4	INC. DCN ISID2-007B-5 PER DCR 00-1766	SDW	
5	INC. DCN ISID2-007B-4 PER DCR 04-0010 & GEN. UPDATE REMOVE SHT. 2 (DOUBLE CALLOUT) AT ZONE C-3 PER ENGR COMMENT AND ISIM REVIEW		INITIALS ON FILE
6	INC. DCN ISID2-007B-3 FOR RFA 93-0482		INITIALS ON FILE
7	INC. DCN'S ISID2-007B-1 & 2 FOR DCR 91-001		INITIALS ON FILE
8	ISSUED FOR SECOND 10 YEAR ISI PROGRAM	JJK	FIN TMB MCP ECC
NO.	DATE	REVISIONS	BY
SCALE N.T.S. DESIGNED: [] DRAWN: CB DATE: []			
DAVIS-BESSE NUCLEAR POWER STATION UNIT NO. 1			
INSERVICE INSPECTION DIAGRAM STEAM GENERATOR SECONDARY SYSTEM			
DRAWING NO. ISID2-007B		REV. 4

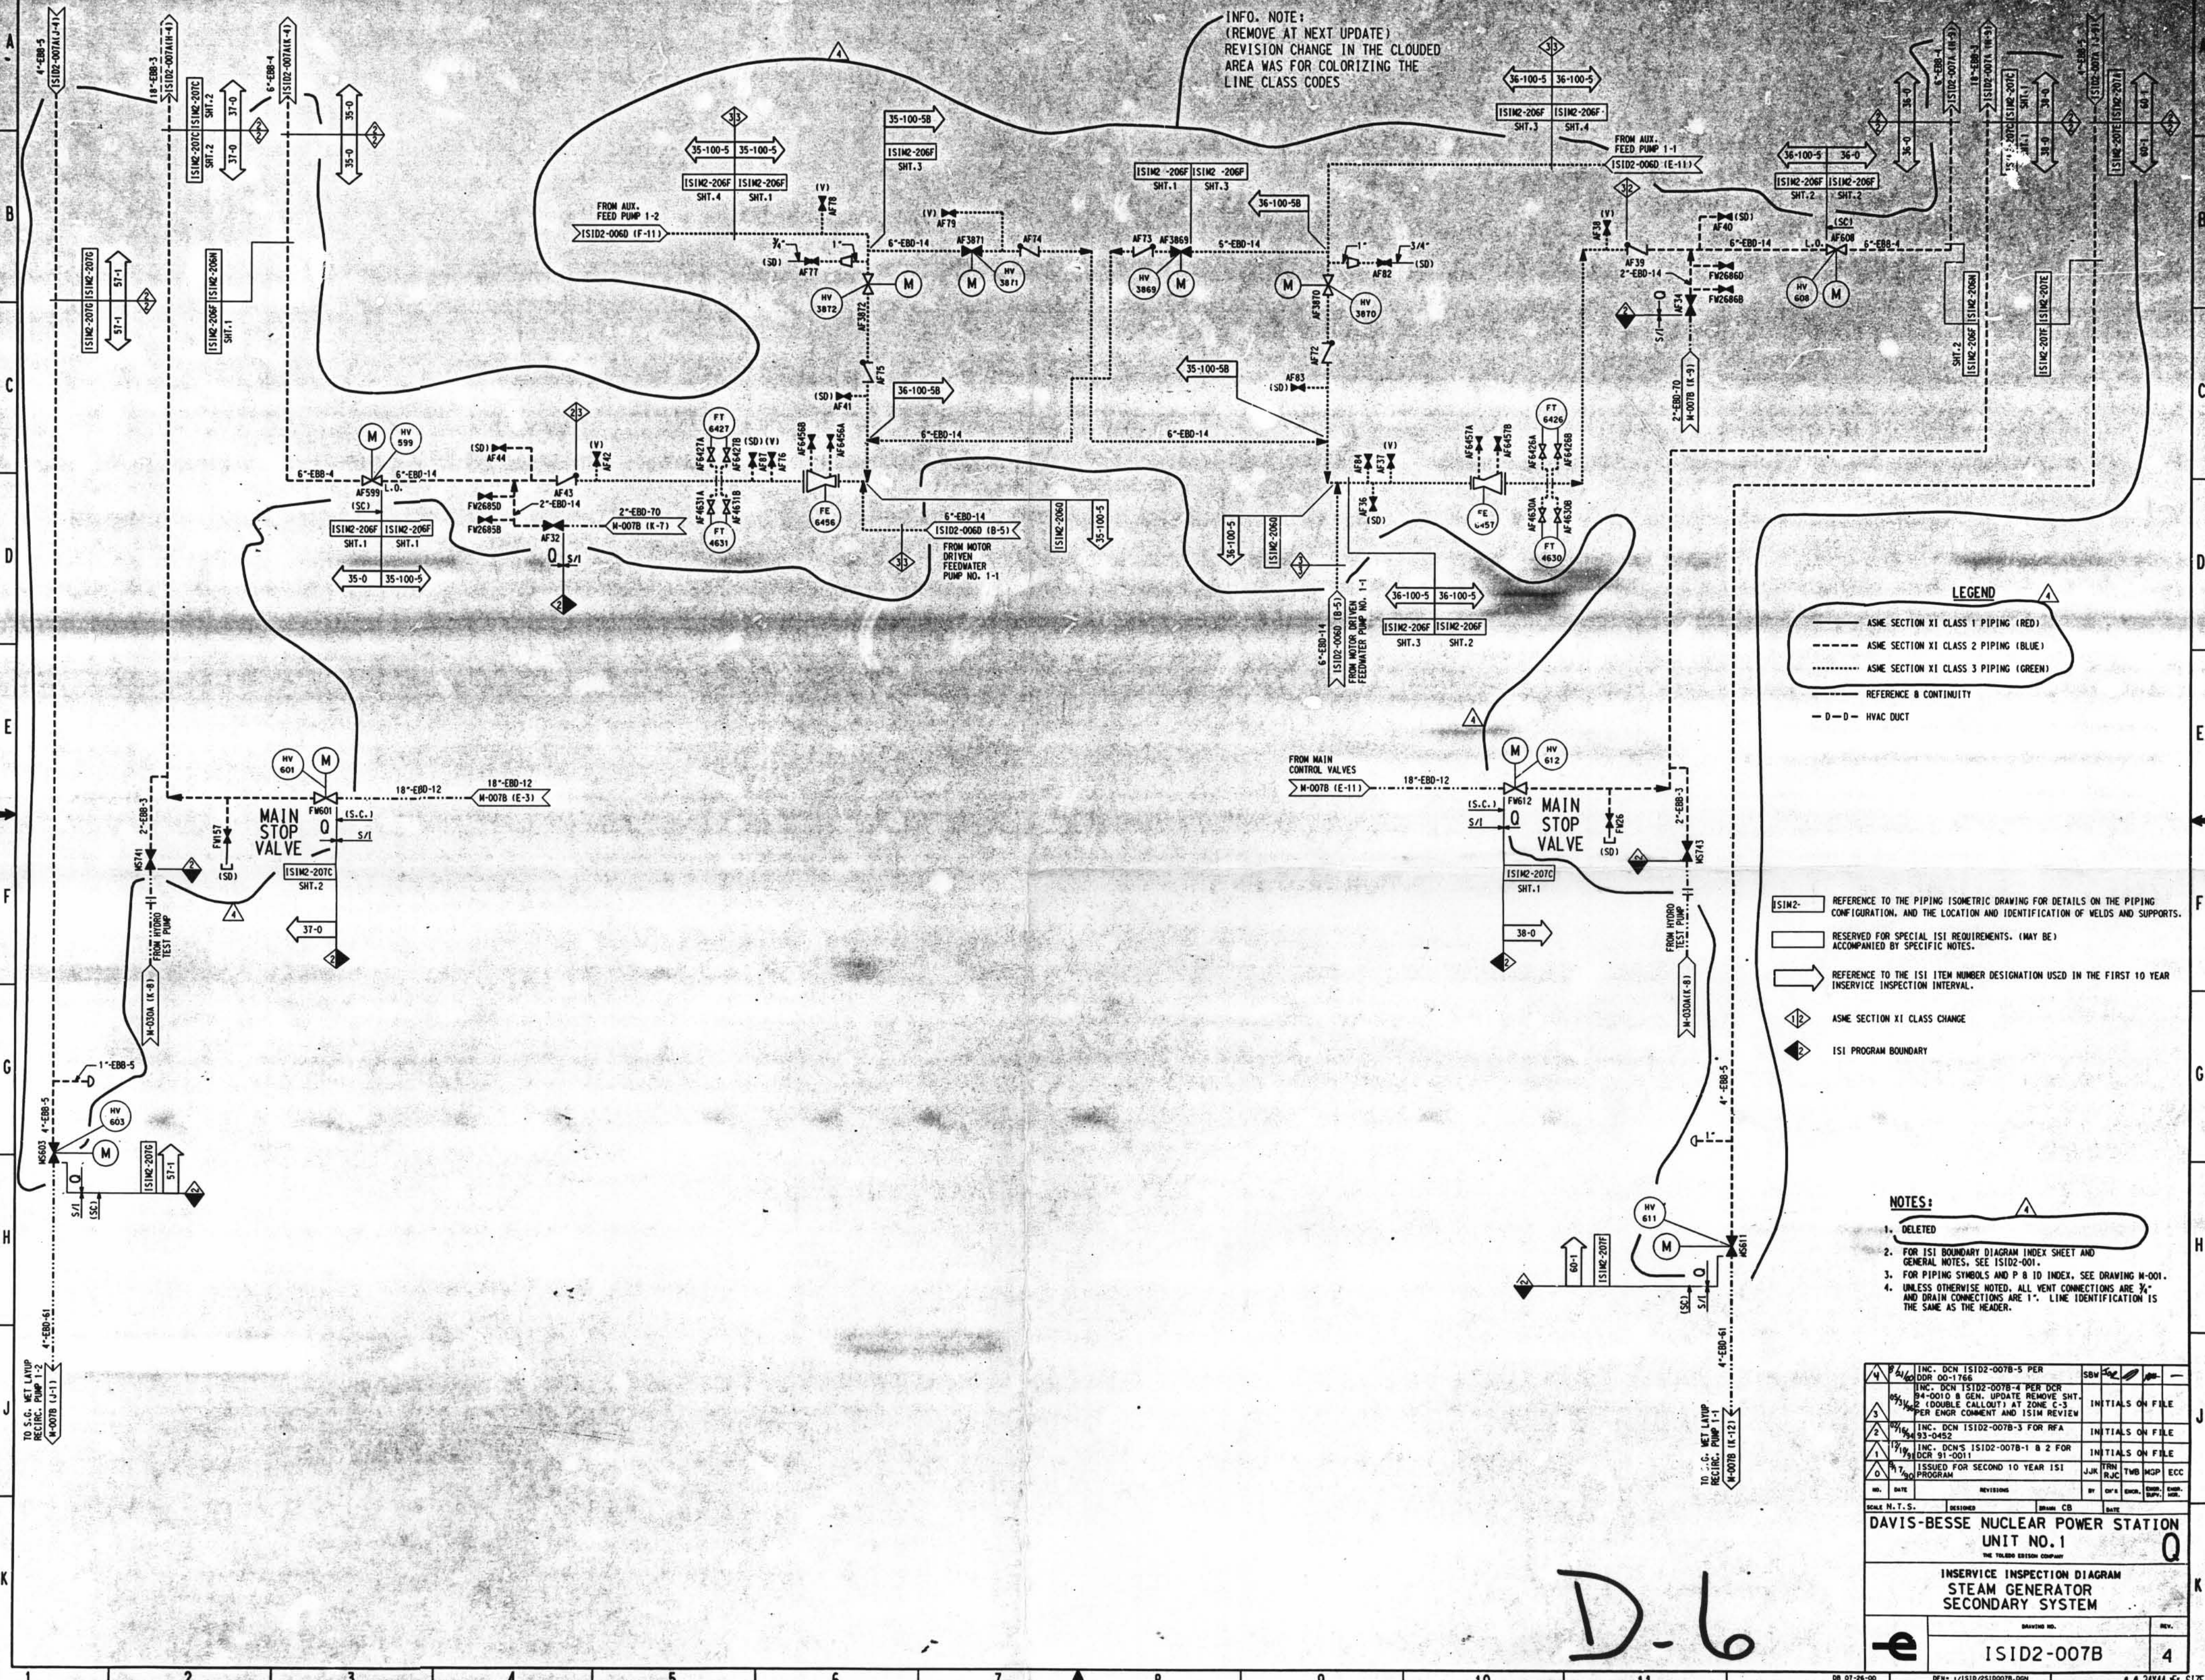
INFO. NOTE:
(REMOVE AT NEXT UPDATE)
REVISION CHANGE IN THE CLOUDED
AREA WAS FOR COLORIZING THE
LINE CLASS CODES
